<b>Delegated Report</b>		<b>Analysis sheet</b>		<b>Expiry Date:</b>		05/03/2020	
		N/A		<b>Consultation Expiry Date:</b>		30/01/2020	
<b>Officer</b>				<b>Application Number(s)</b>			
Nora-Andreea Constantinescu				2021/2918/P			
<b>Application Address</b>				<b>Drawing Numbers</b>			
40 Arkwright Road London NW3 6BH				See decision notice			
<b>PO 3/4</b>		<b>Area Team Signature</b>		<b>C&amp;UD</b>		<b>Authorised Officer Signature</b>	
<b>Proposal(s)</b>							
Removal of front boundary wall, front planter and hardstanding to create vehicular access and onsite parking with vehicular crossover (partial retention)							
<b>Recommendation(s):</b>		Refuse planning permission with warning of enforcement action					
<b>Application Type:</b>		Full Planning Permission					
<b>Conditions or Reasons for Refusal:</b>		<i>Refer to Draft Decision Notice</i>					
<b>Informatives:</b>							
<b>Consultations</b>

- 1.1 Planning permission is sought for the removal of front boundary wall, planter and hardstanding to create vehicular access and onsite parking with vehicular crossover.

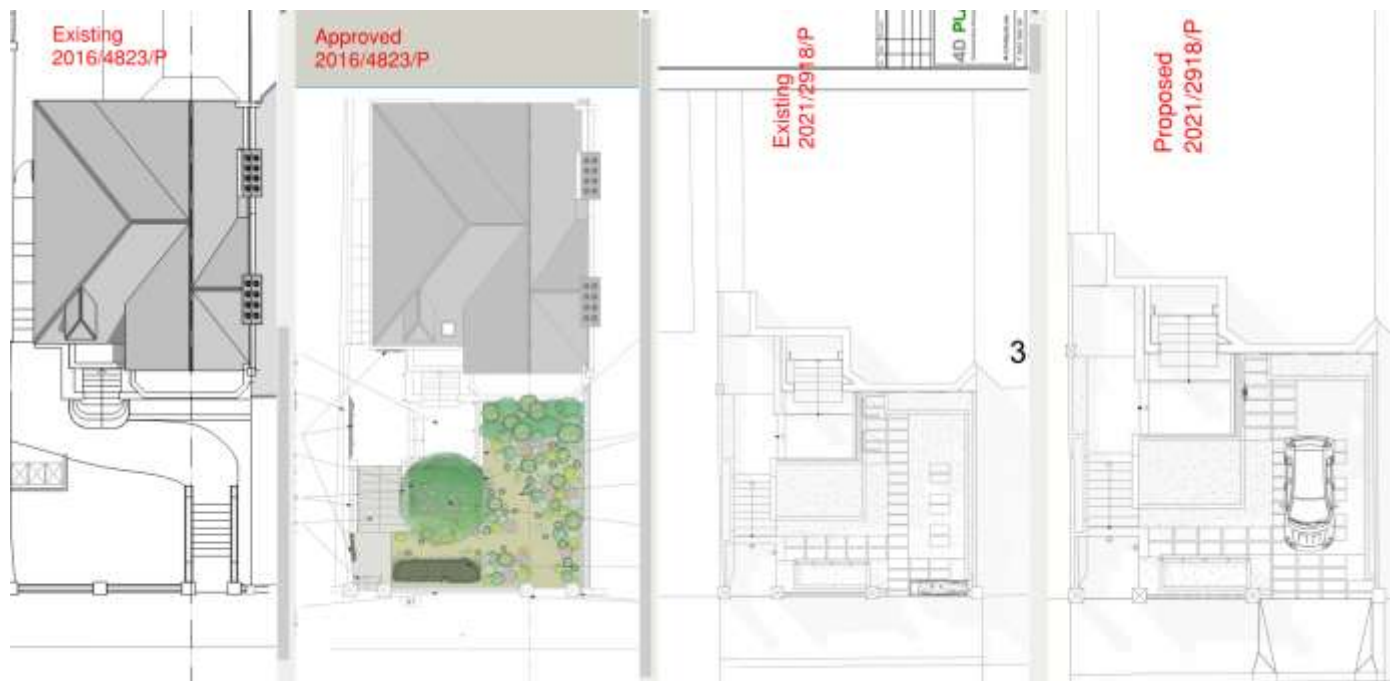
- 1.2 The proposed driveway would measure approximately 22sqm, 3.3m wide and 7.2m length. The proposed plans show the area of driveway without the hatch representing soft landscaping and therefore is understood that this would become hardstanding. The proposal would therefore result in a reduction of soft landscaping in the front garden by 66% from what was granted consent as part of the 2016 permission, as explained below (in section 2).

- 1.3 A section of approximately 2.5m of boundary wall was not built as per the plans approved under application ref 2016/4823/P, as explained below (in section 2).

- 1.4 The proposed vehicular crossover (dropped kerb) would measure 4.10m wide to allow access to the new off-street car parking space.

garden. As part of this submission, a boundary wall with a length of approximately 6.5m had been secured, with a small gap at the eastern end, adjacent to property no. 38 Arkwright Road. The current submission shows a boundary wall with a length of approximately 4m which is, 2.5m shorter than the one previously approved. This appears to have been done with a view to securing an anticipated car parking space.

2.3 The current submission shows as existing a different scheme was implemented with an increase in hardstanding areas by 5sqm. (approved plans show soft landscaping areas of 33sqm; existing plans submitted with the current application shows 28sqm of soft landscaping).
